Consumers
Power
Company

MIDLAND PROJECT -
ALAB-106 MONTHLY REPORT FOR JANUARY 1981
DOCKET NOS 50-329 AND 50-330
FILE: 0.4.6 UFI: 70*01 SERIAL: 11196

In accordance with Condition of Memorandum and Order ALAB-106, dated March 26, 1973, and Amendment No 1 of the Midland Plant Construction Permit, enclosed are ten copies of the following documents written or closed during the month: Bechtel Nonconformance Reports, sheets from the Bechtel Nonconformance Report Log; Bechtel Quality Action Requests; Bechtel Management Corrective Action Reports; Babcock & Wilcox Reports of Nonconformity; B&W ISI NCR's; and Consumers Power Company Nonconformance Reports, Audit Finding Reports, Quality Action Requests, and Corrective Action Reports.

20 PAGE 2 OF 2 19NCR NO 3254

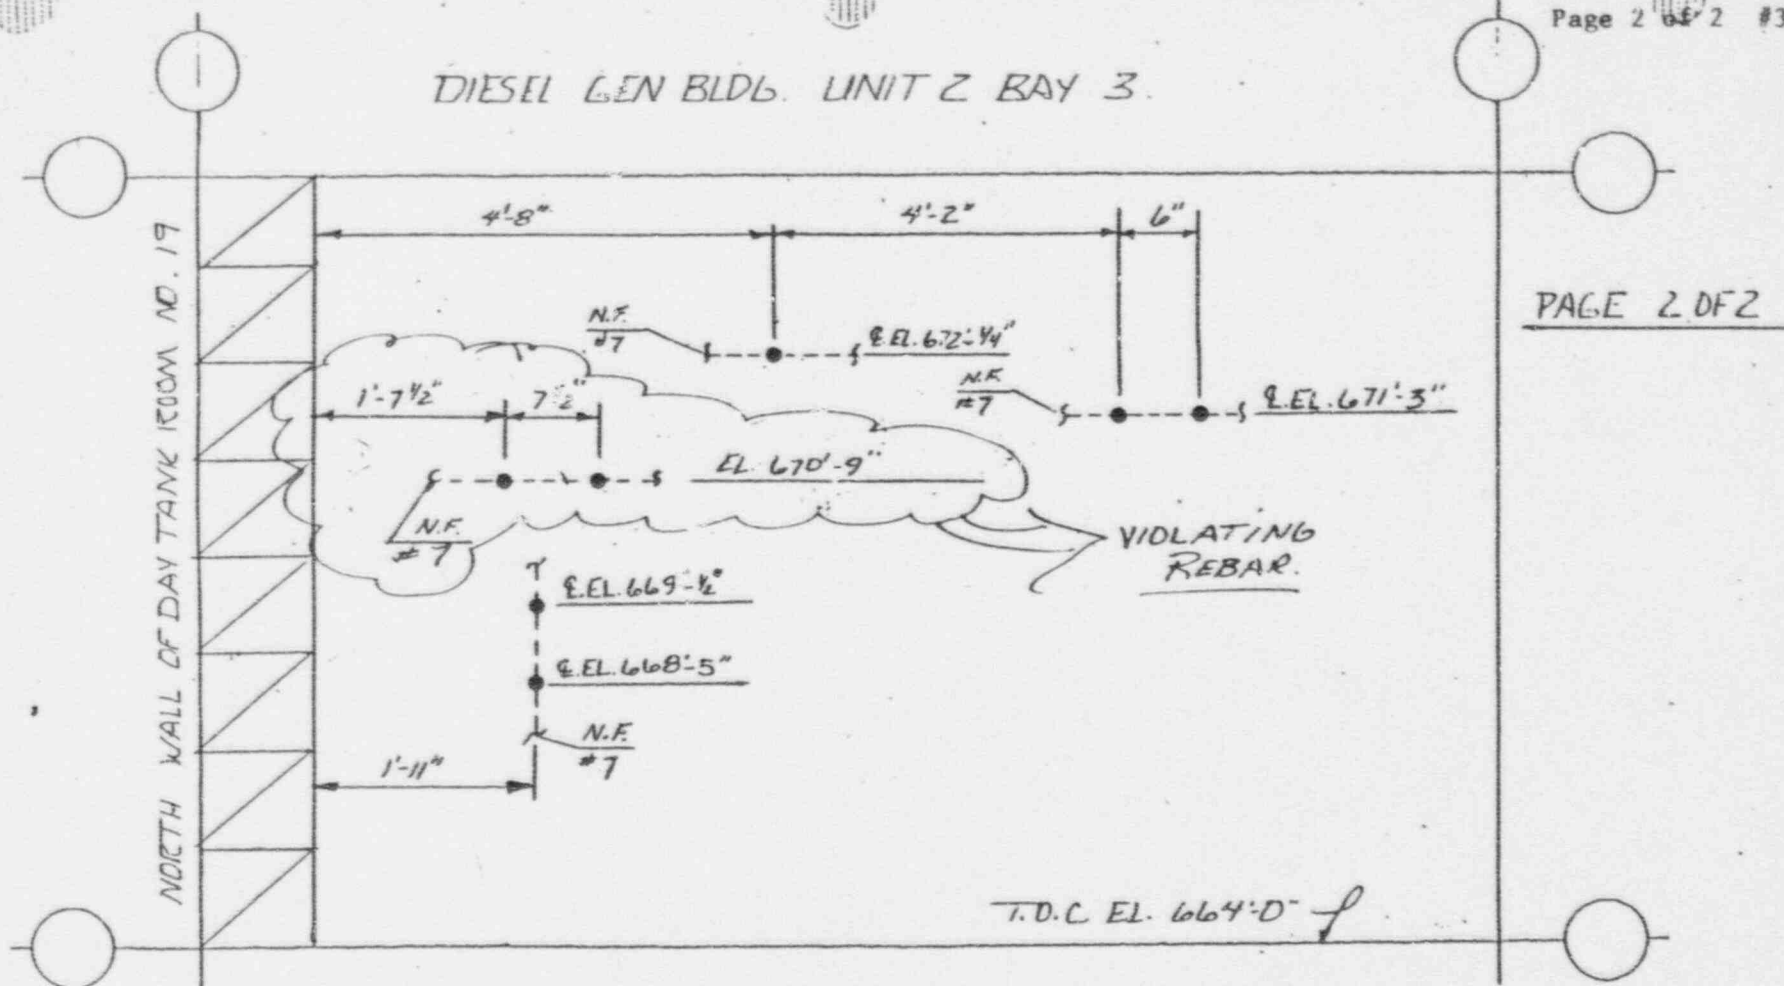
15. Equip Furnished By () Client () Eng () FCD							
16. NONCONFORMING CONDITION: REQUIREMENT: SPEC 11204 REV 14 Paragraph 8 states in part "The piping shall be kept in appearance, provide adequate space for pipe insulation, be convenient to operate and shall provide for proper expansion, venting and drainage". Continued on Pg 2 "D"-6155 # 4037 1 Hold Tag Applied

NCR # 3261

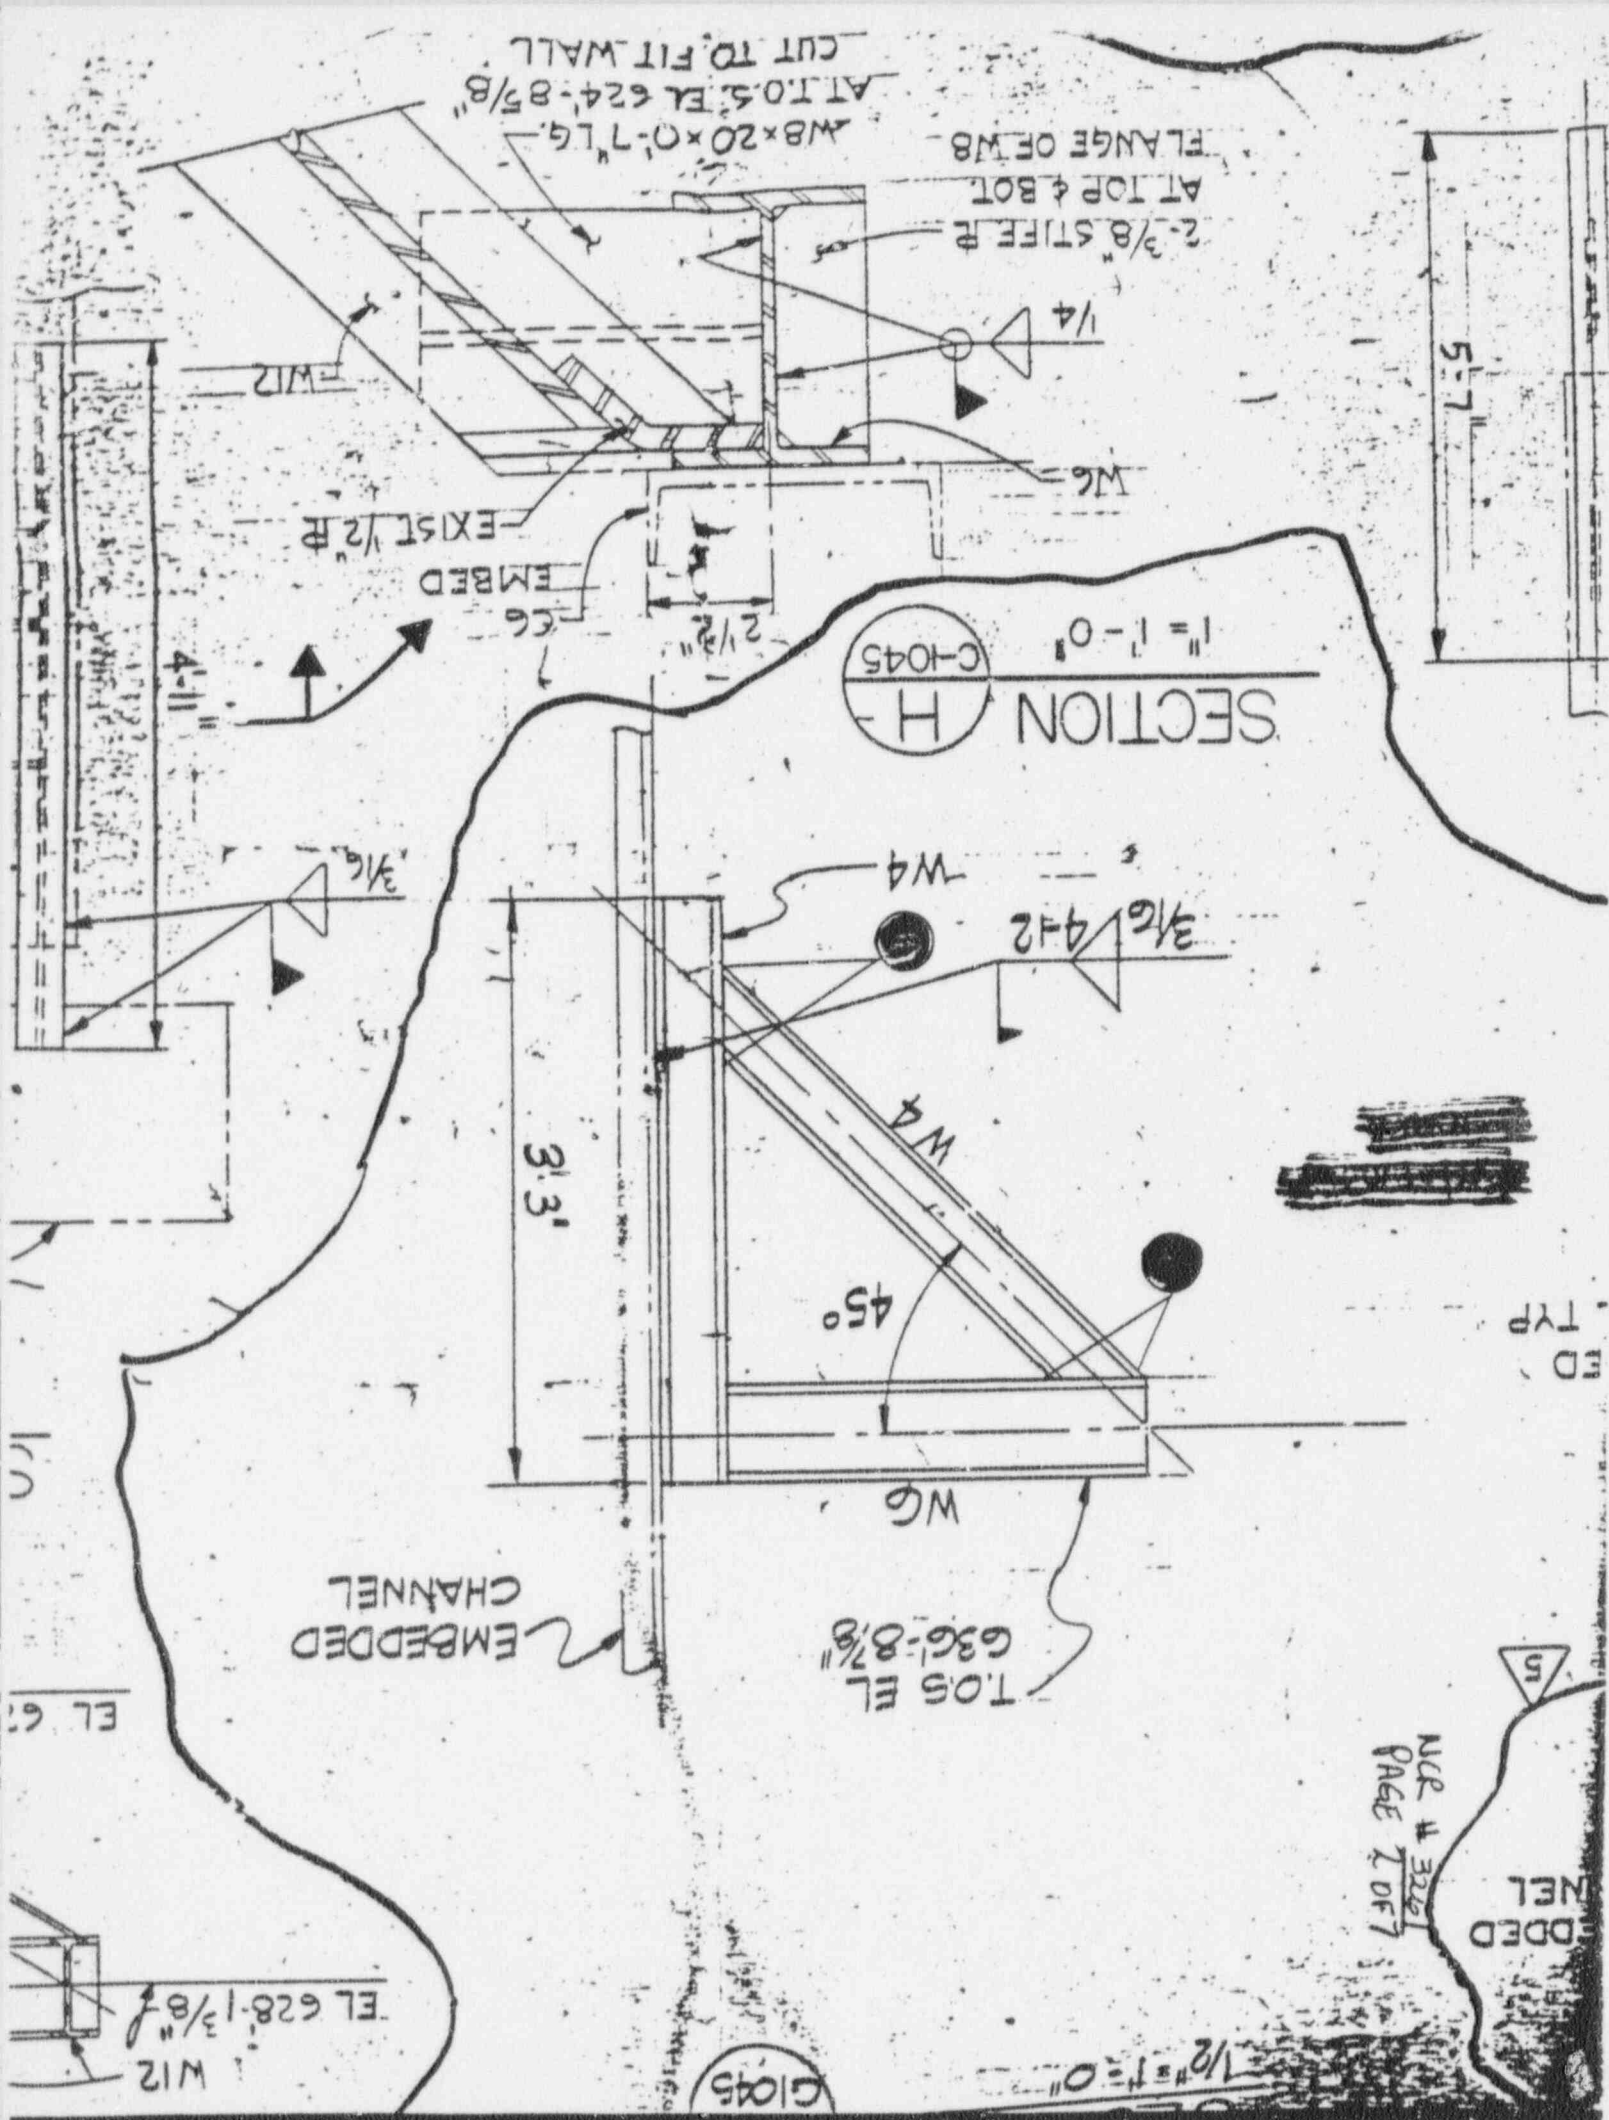
1. Project Name MIDLAND		Job No. 7220		19. No. 3261		20. Page 1 of 2	
2. Unit(s) 1		3. Drawing/Part No. N/A		4. Item Description Cross Flange Welding ACCESS PLATFORM STRUCTURAL STEEL		5. Item Location EL. 6.26 ± TO EL. 6.35 ± S. STEEL GENERAL

BACK TO BACK INSTALLATIONS, MIX. BLDG., EL. 614 ARE:

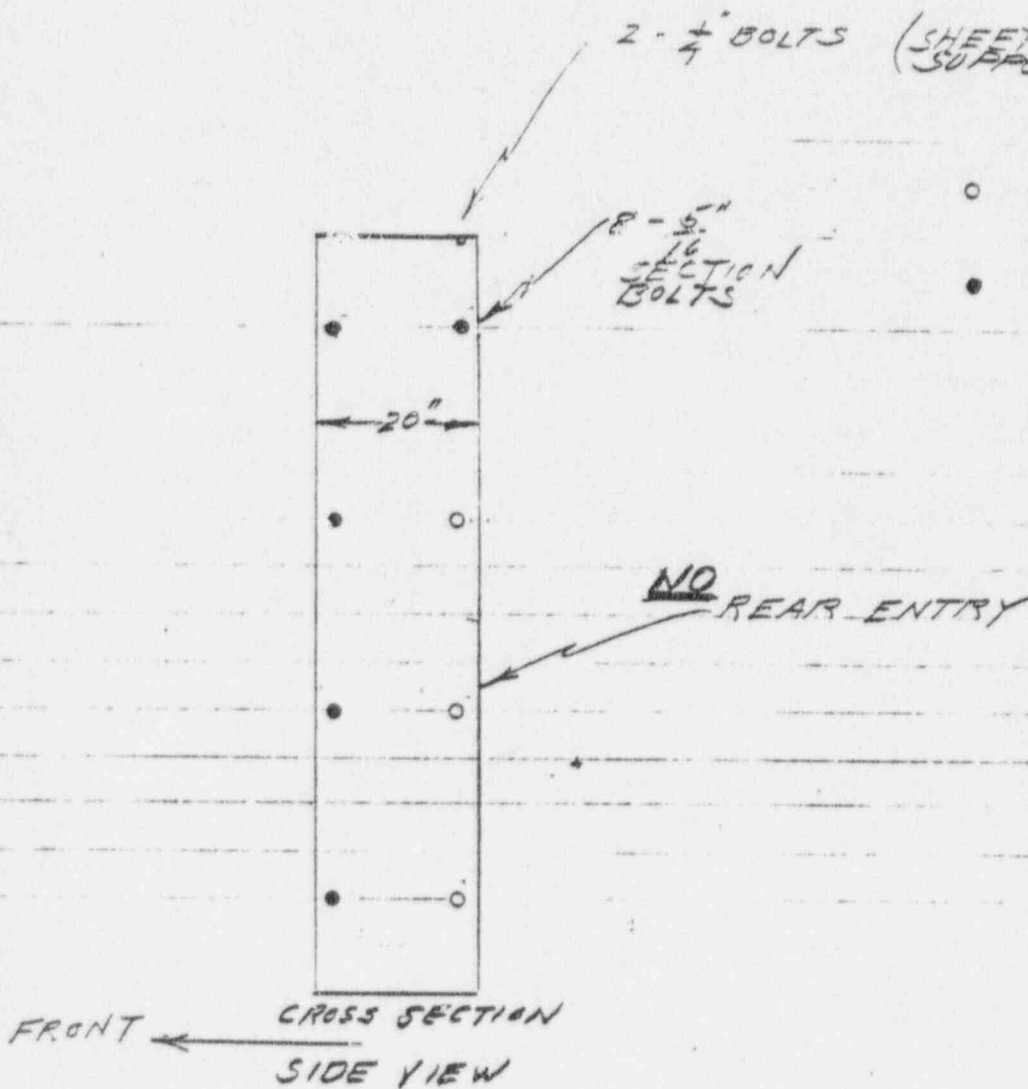
DOUBLE ENTRY UNITS ARE BEING USED SINGLE ENTRY WHERE THEY ARE BACK TO BACK OR AGAINST THE WALL, WITH NO REAR ENTRY. DRAWING IMPLIES BOLTS AT THE TOP ON BOTH SIDES OF THE BUS'S SPLICE TO SECURE THE CABINET.

EXAMPLE: THE FIRST MCC OF A BACK TO BACK INSTALLATION, ALL EIGHT BOLTS CAN BE INSTALLED AS IS EVIDENT IN 2B5E. THE SECOND MCC HAS NO TOP REAR BOLT AS IS EVIDENT IN 2B23. SIX VISUAL INSPECTIONS THROUGH THE TOP OPENING REVEALS FIVE MISSING BOLTS. A WRITER SKETCH OF BOLTS REQUIRED IS ATTACHED (PAGE 3). ALSO IT IS NOT POSSIBLE TO INSTALL THE TOP REAR BOLT IN 2B5E BETWEEN SECTIONS FIVE AND SIX.

FLOOR SLAB

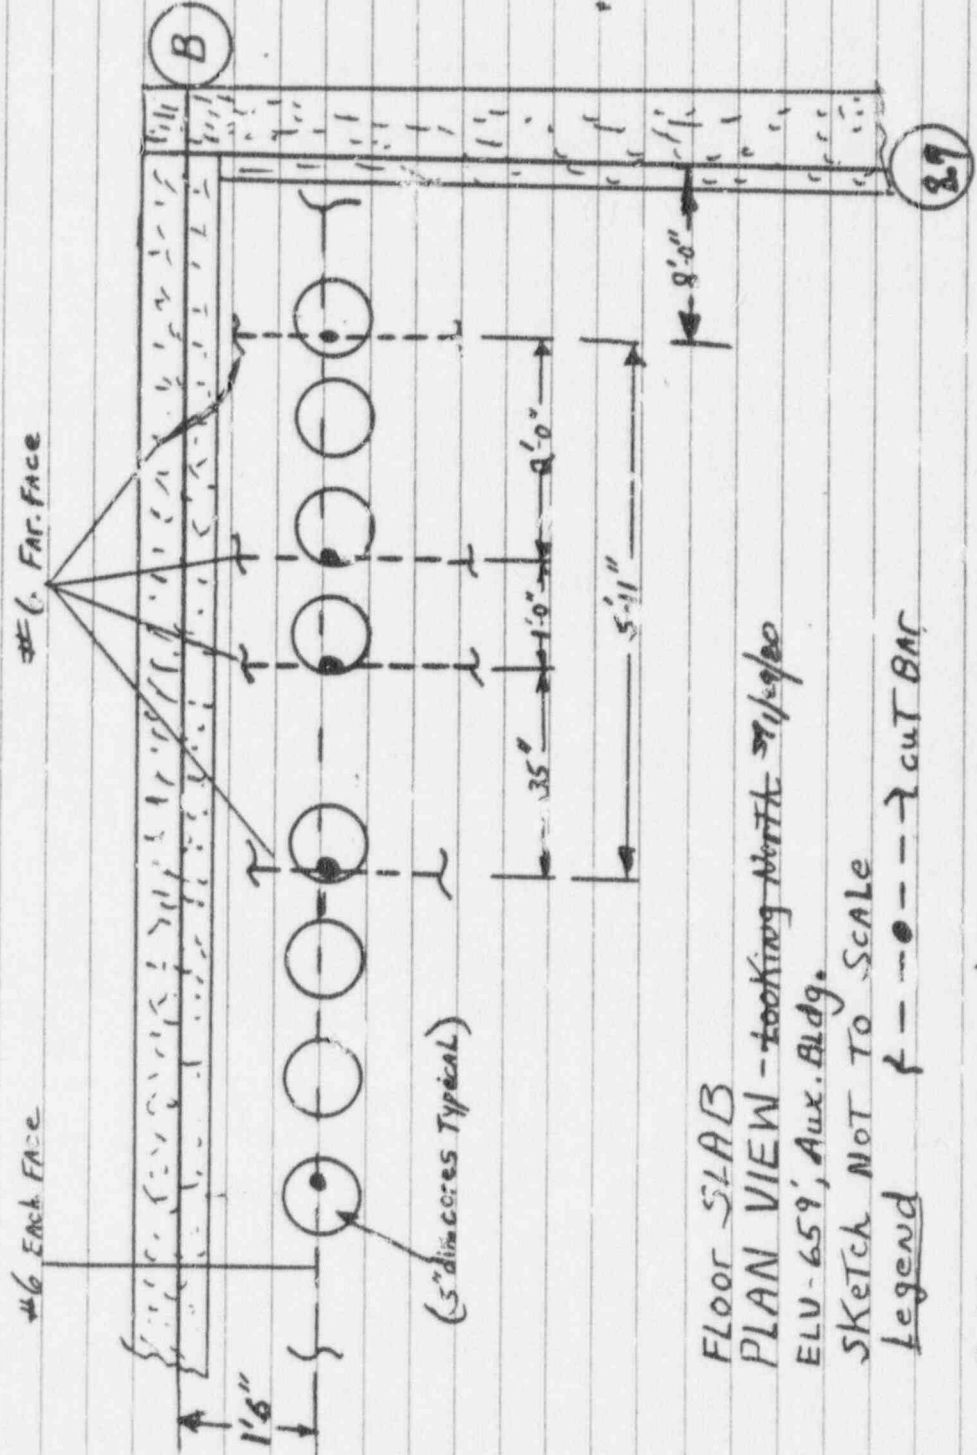
1. PROJECT NAME		JOB NO.		19. NO.		PAGE 1 OF 2	
MIDLAND UNITS 192		7220		3273			
2. UNIT(S)		3. DRAWING/PART NO.		4. ITEM DESCRIPTION		5. ITEM LOCATION: Max. 819	
Common		N/A		N/A		SLAB - E1659

TENDON NO. H21-015

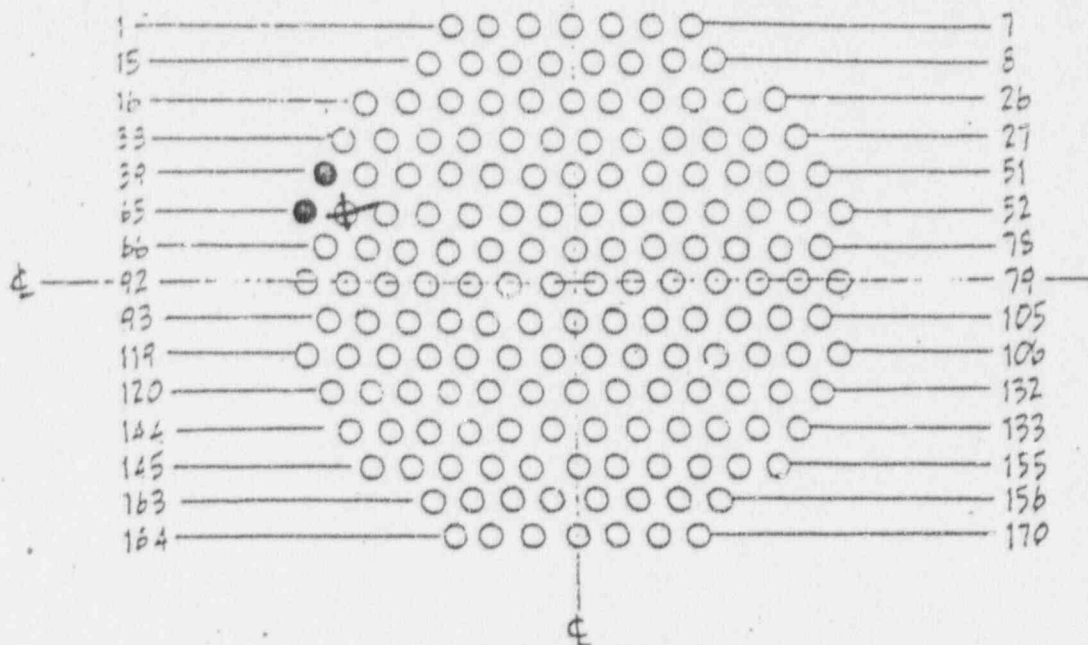
1. PROJECT NAME MIDLAND		JOB NO. 7220		19. NO. 3274		20. PAGE 1 OF 3				
2. UNIT(S) 1	3. DRAWING/PART NO. N/A	4. ITEM DESCRIPTION POST TENSIONING - TENDON WIRE	5. ITEM LOCATION Cut 1 Tendon H21-015

A CONDITIONAL RELEASE IS GRANTED TO STRESS AND GREASE TENDON H21-015 USING A168 WIRE STRESSING CRITERIA AS PER SPEC C2-146. COMPLETION OF THIS WORK DOES NOT ELIMINATE THE CONDITION DESCRIBED IN BLOCK #16. CORRECTION OR REMOVAL CAN BE ACCOMPLISHED WITHOUT CAUSING DAMAGE OR CONTAMINATION TO ASSOCIATED PLANT EQUIPMENT OR STRUCTURE.

"Q" LISTED # 4.173

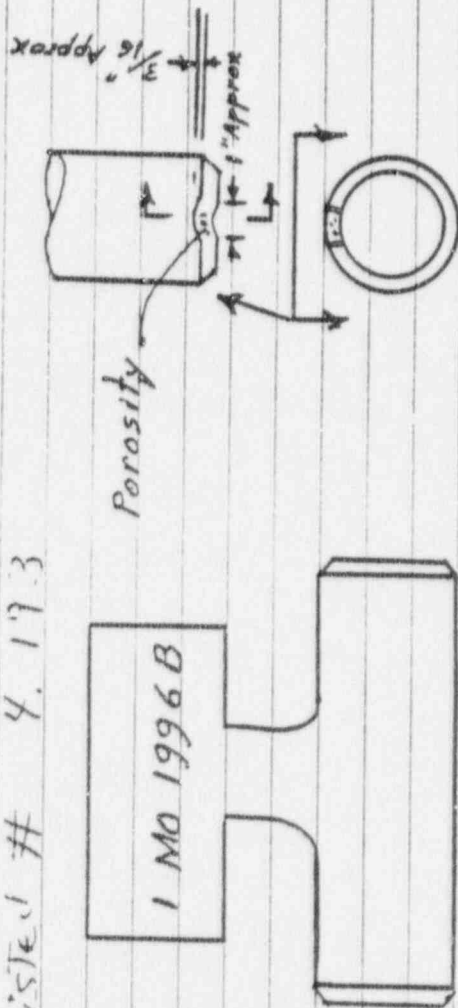
Contrary to the above, a gouge exists in one end of the valve, and porosity is visible in the bottom of the gouged area as shown below:

JOB NUMBER	UNIT NUMBER	DATE	REPORT OF NONCONFORMITY #
CL-238	Unit #1	1-15-81	1765

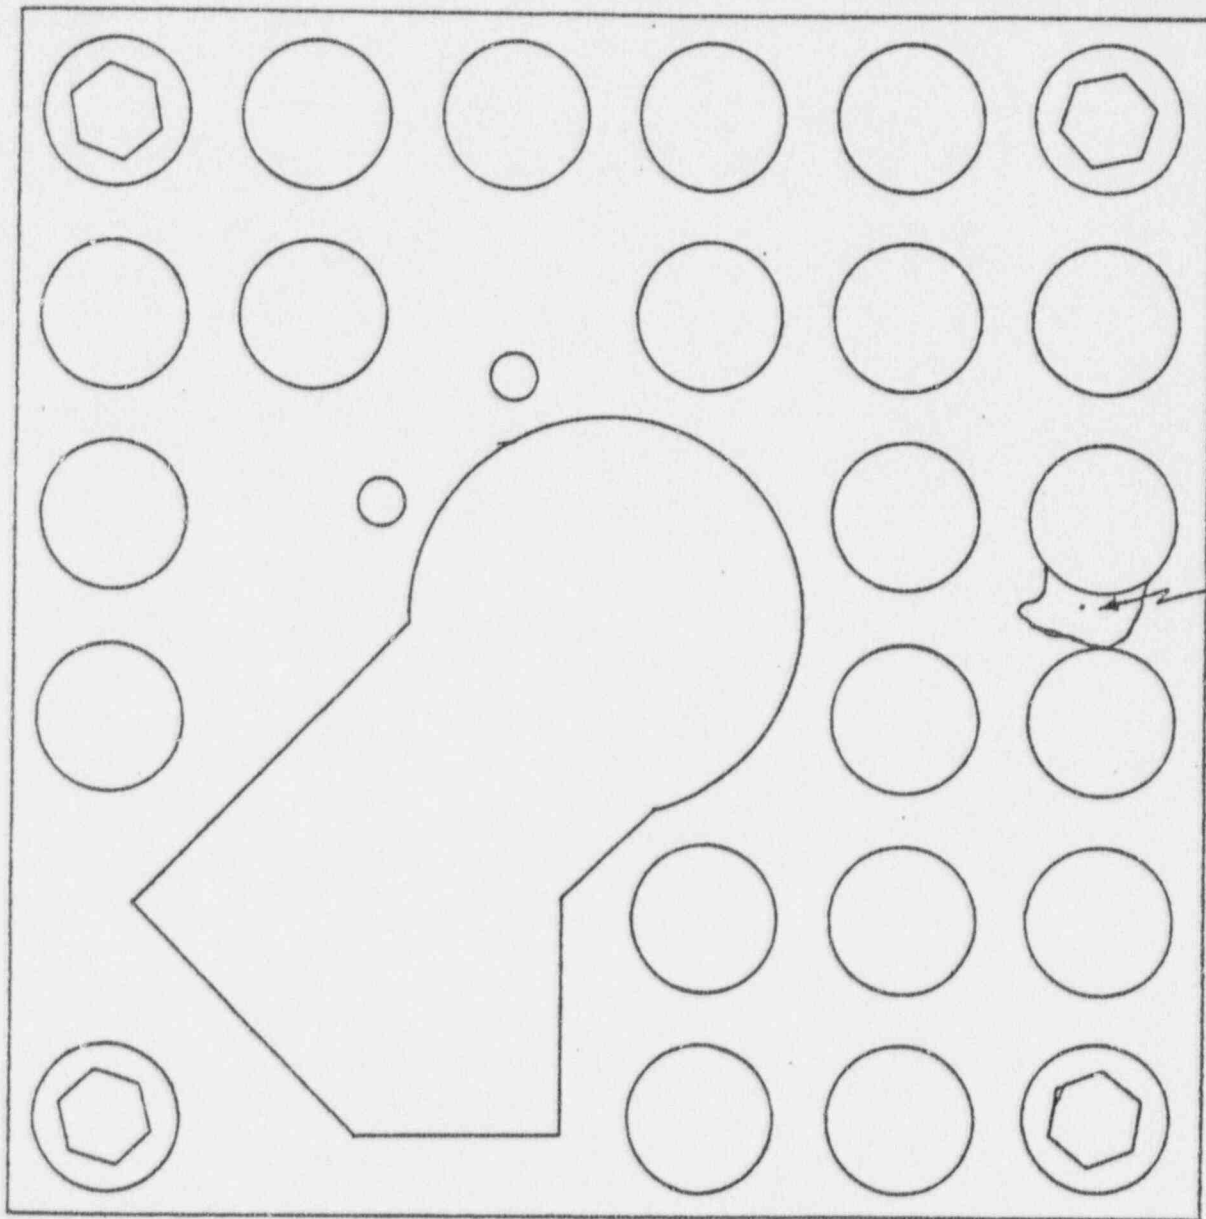
9. PROCEDURE NUMBER FCP #102		10. SPECIFICATION NUMBER N/A		
11. DRAWING NUMBER 203269E, Rev. 1		12. PRIOR REPORT OF NONCONFORMITY? N/A		
13. DESCRIPTION OF NONCONFORMITY An arc burn was created by a short in a welding cable at the edge of a hole in tie plate #12. (See sketch on Page 2 of 2).

1. Replace plug in 1P51C return line and add additional air pressure to tire to hold in place and re-fill reactor vessel.
2. Pump and/or drain water out of bottom of steam generator, C and D suction lines.

3. Cover openings at bottom of steam generator until water is removed from reactor vessel.
4. After reactor vessel examination is complete and water is removed, perform the following:
